## **STAFF REPORT**

**TO:** City Council  
**FROM:** Ken Roberts, Planning Director  
**AGENDA ITEM:** Union Park West Addition – Final Plat  
**REVIEWED BY:** Jack Griffin, City Engineer

# UNION PARK WEST

# MEMORANDUM

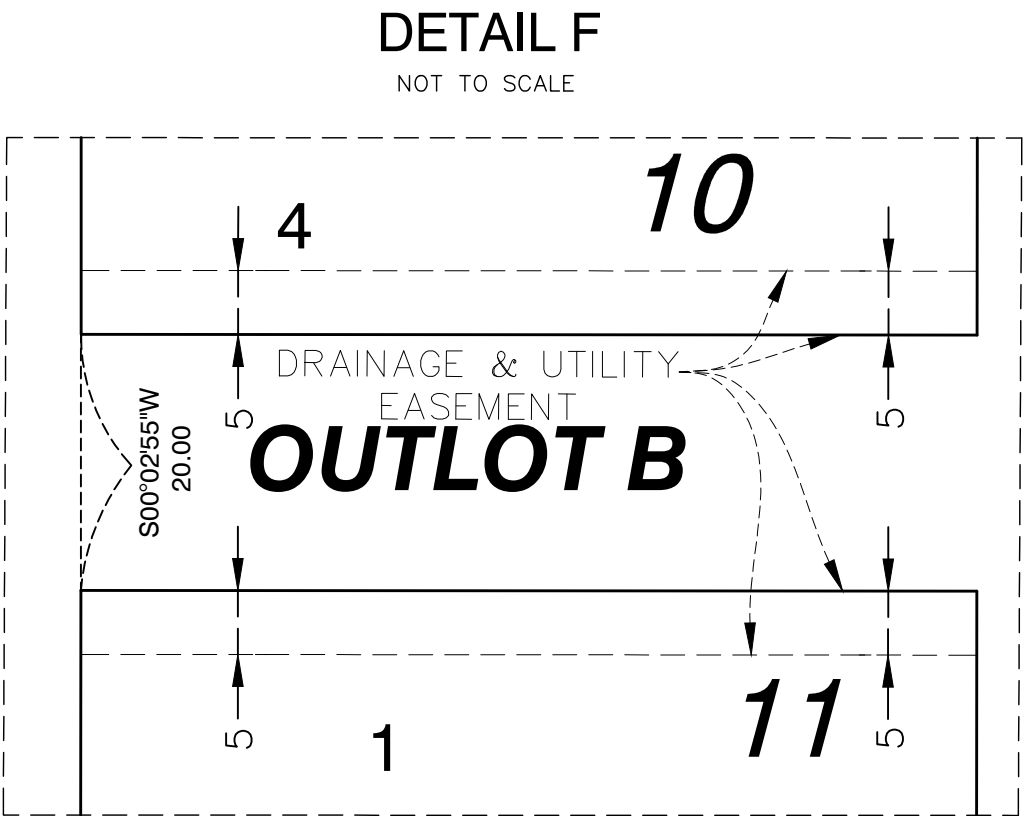
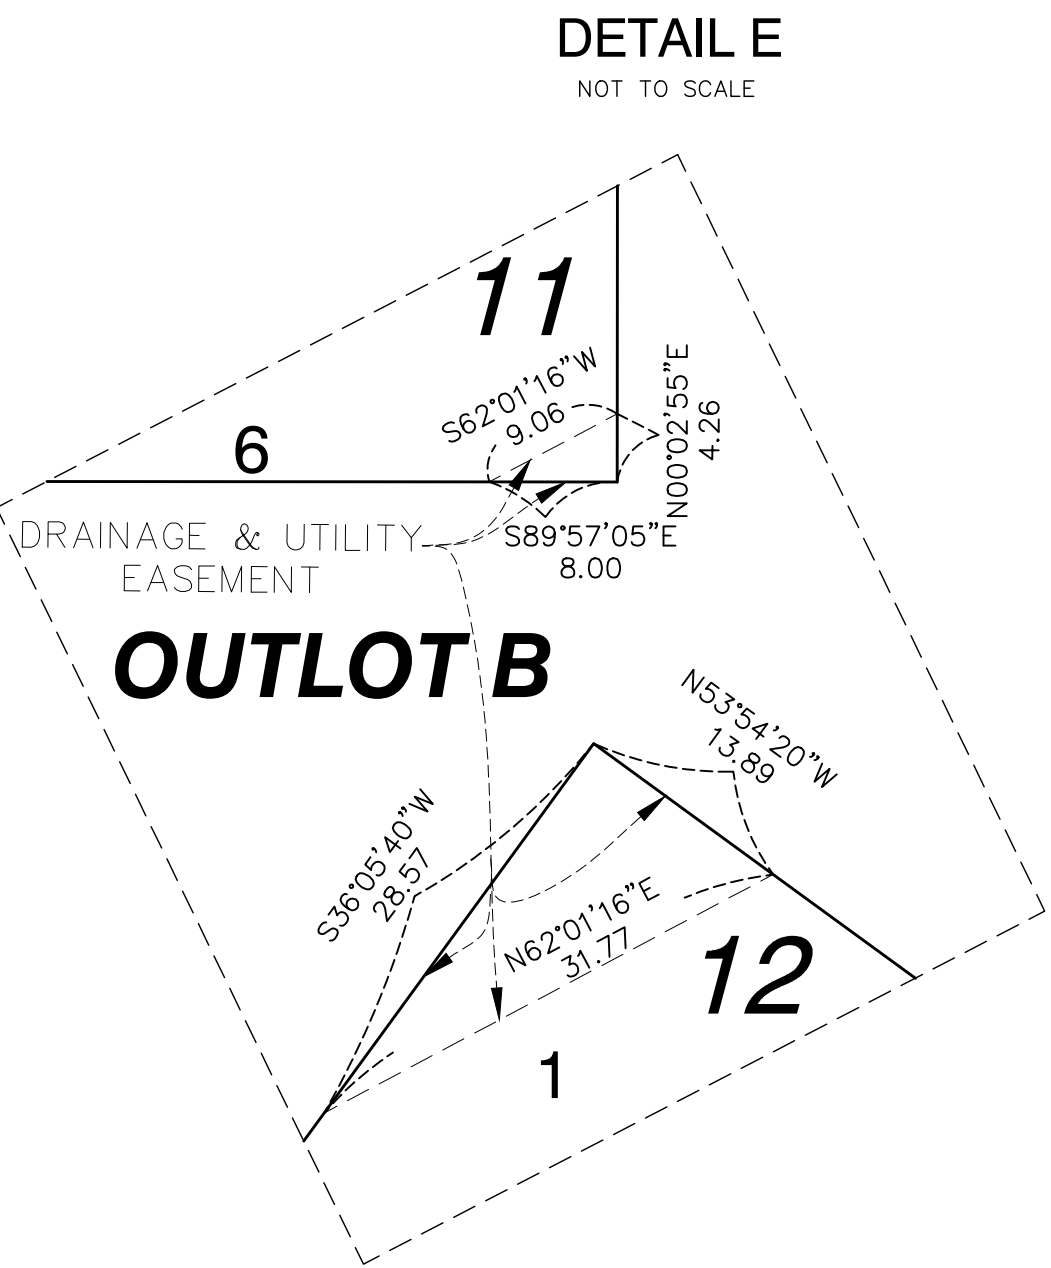
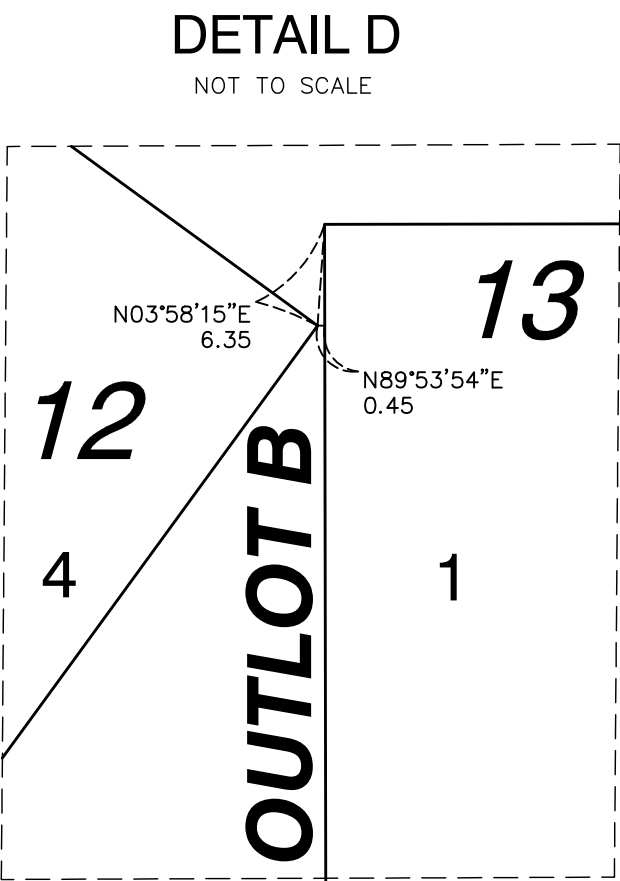
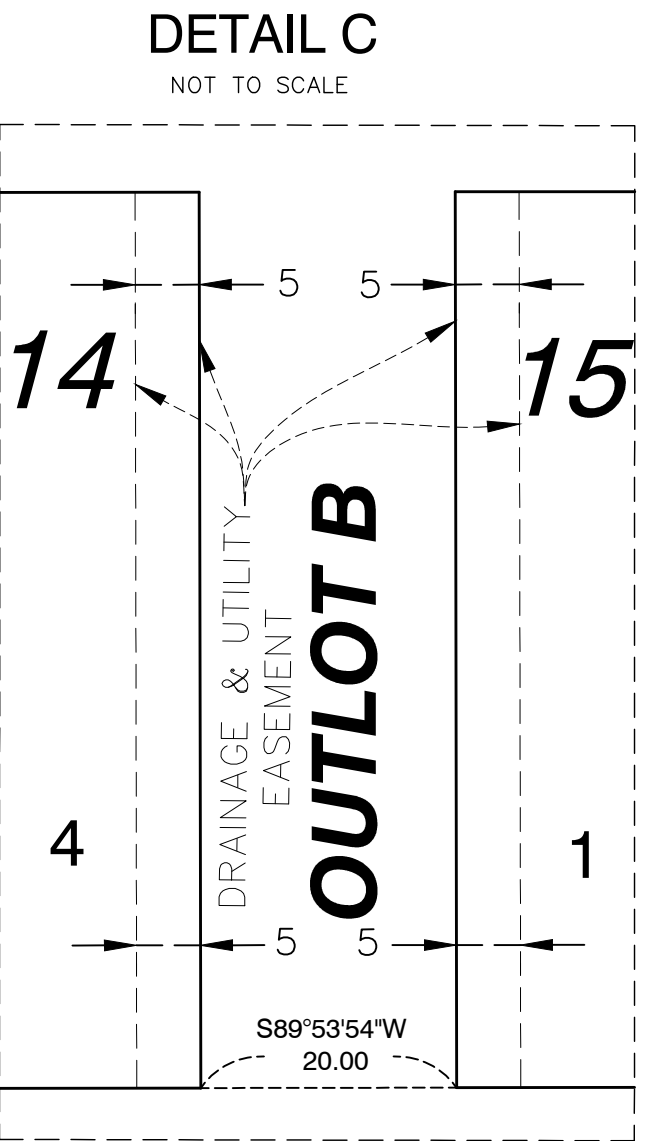
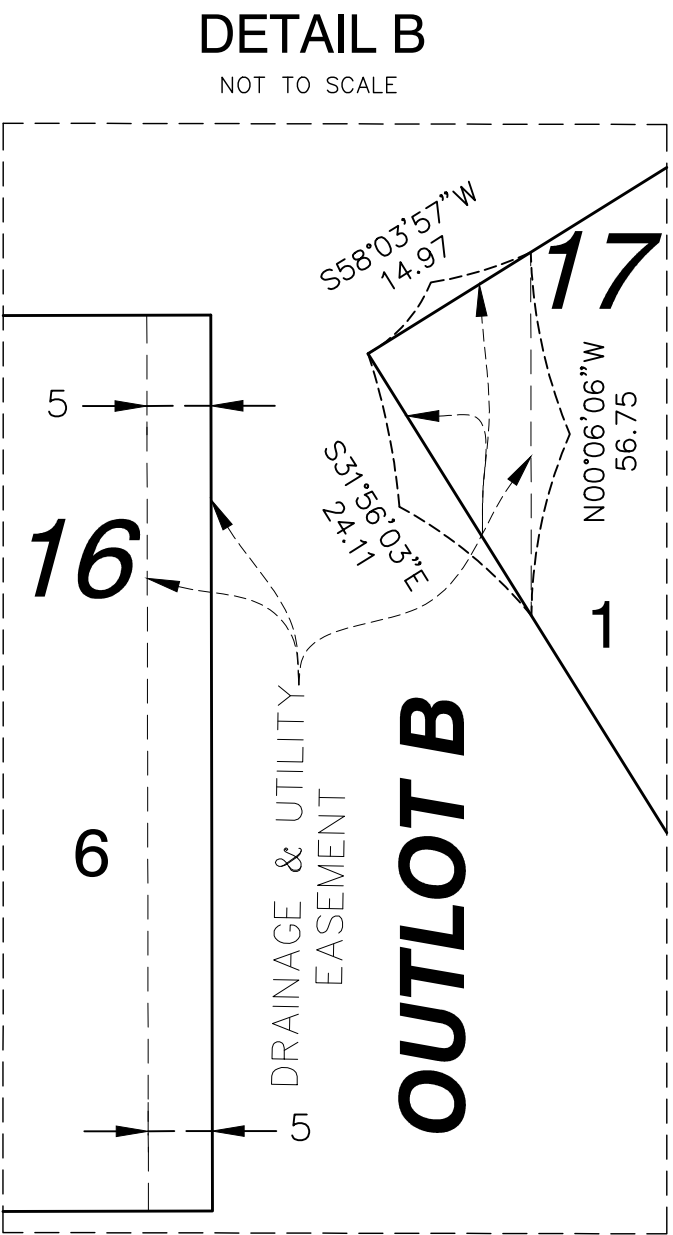
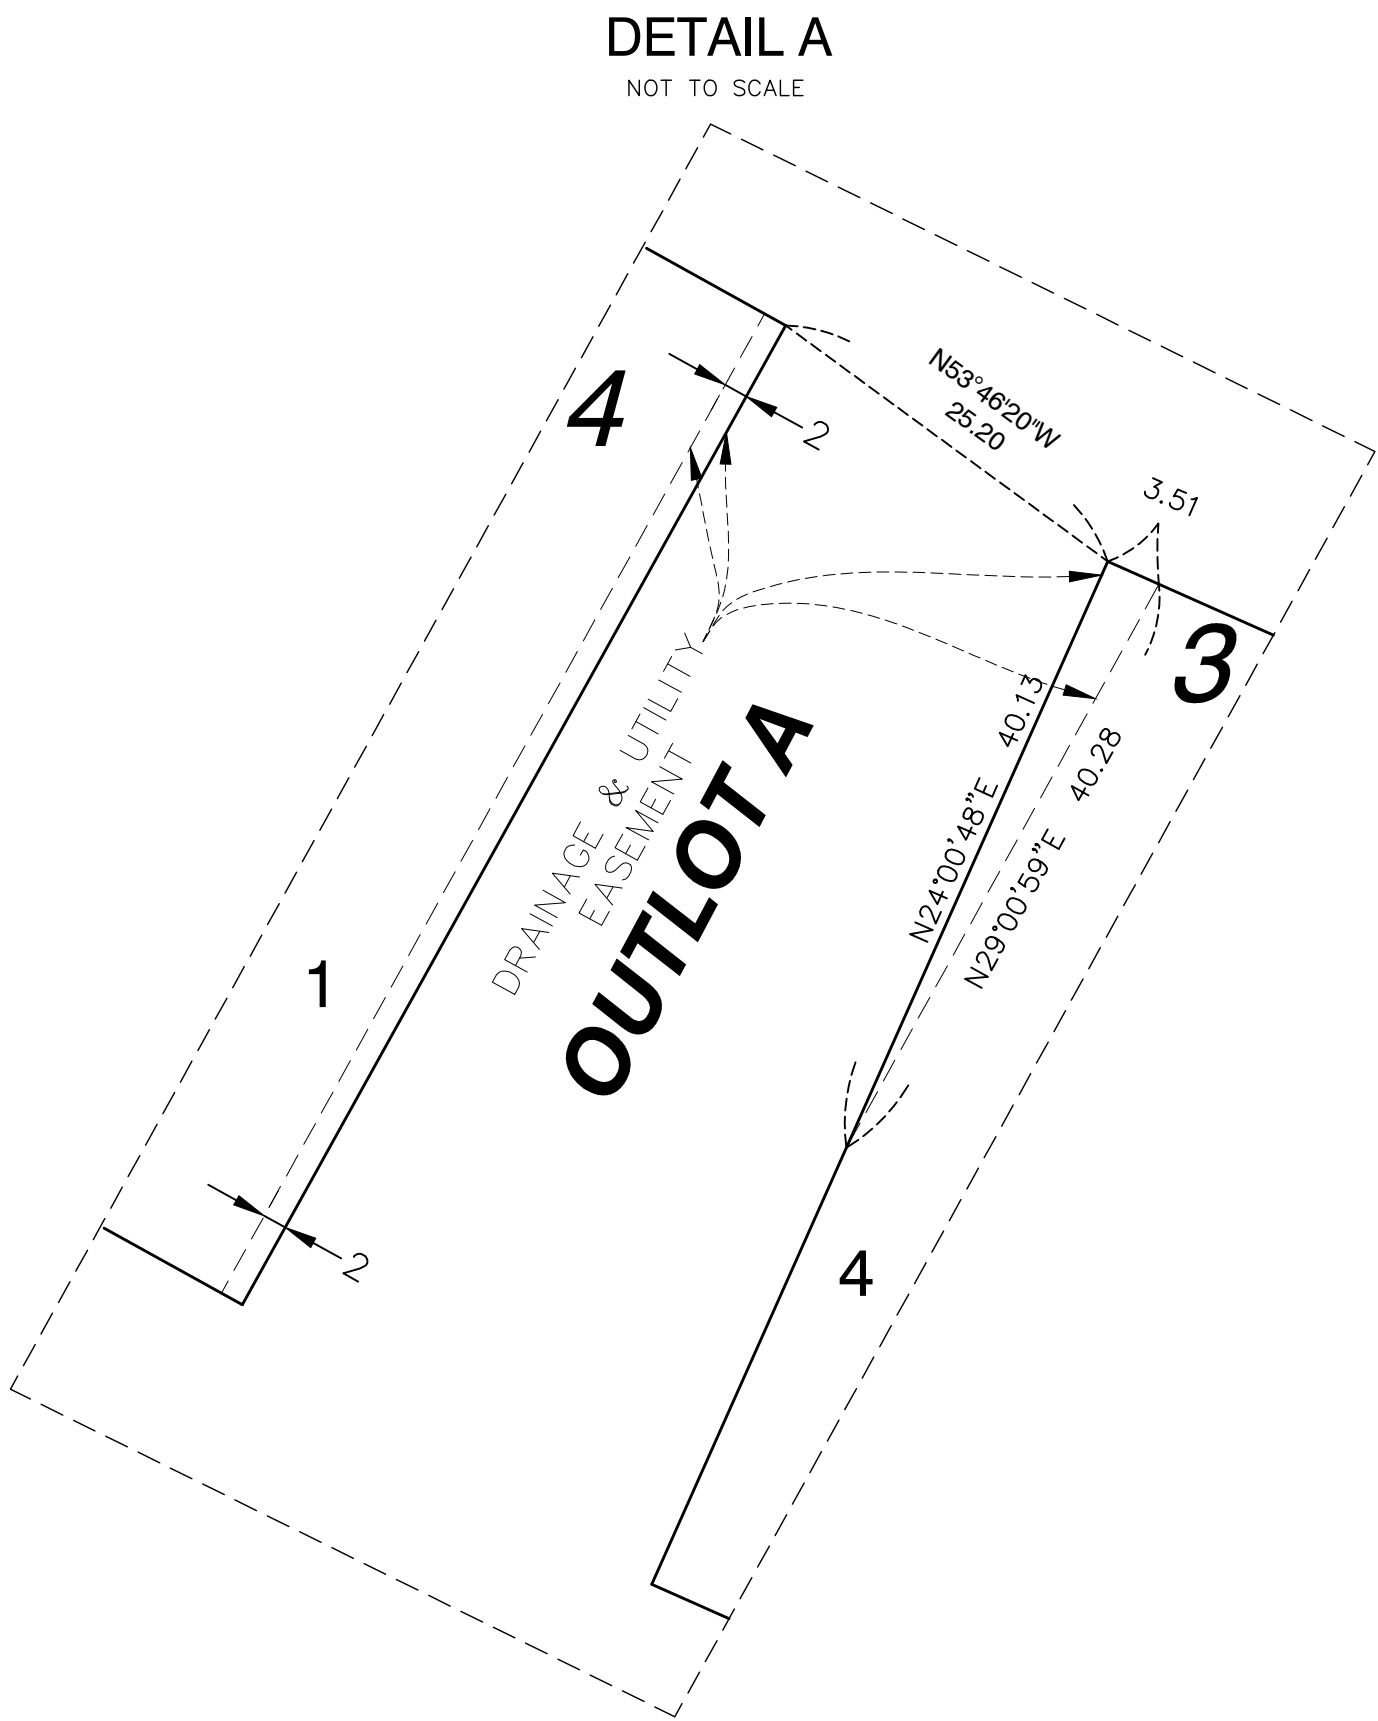
- Additional drainage and utility easements have been shown on the plat over Lot 4, Block 3; Lot 1, Block 4; Lot 4, Block 10; Lot 1, Block 11; Lot 6, Block 11; Lot 1, Block 12; Lot 4, Block 14; Lot 1, Block 15; Lot 6, Block 16; and Lot 1, Block 17. Final Plat approval should be contingent upon plat and plan revisions necessary to restore the maximum allowed lot easements as approved with preliminary plat. The development layout went through several preliminary plat iterations and the maximum allowable lot easements were determined for public utility infrastructure (storm sewer and watermain piping) as part of the preliminary plat approval. The proposed final plat is now increasing the utility encroachments in most circumstances. More specifically the following revisions are required:

- Detail A: Easements as proposed are acceptable.
  - Detail B: Reduce easements on Lot 1, Block 17 and Lot 6, Block 16 back to the maximum lengths and areas approved as part of the preliminary plat.

- Detail C: Remove 5 ft. easements from Lot 1, Block 15 and Lot 4, Block 14 and provide 30 ft. pipe corridor for proposed storm sewer pipe, as approved with preliminary plat.

- Detail E: Reduce easements on Lot 1, Block 12 back to the maximum lengths and area approved as part of the preliminary plat.
  - Detail F: Reduce 5 ft. easements back to 2 ft. easements as approved with preliminary plat.
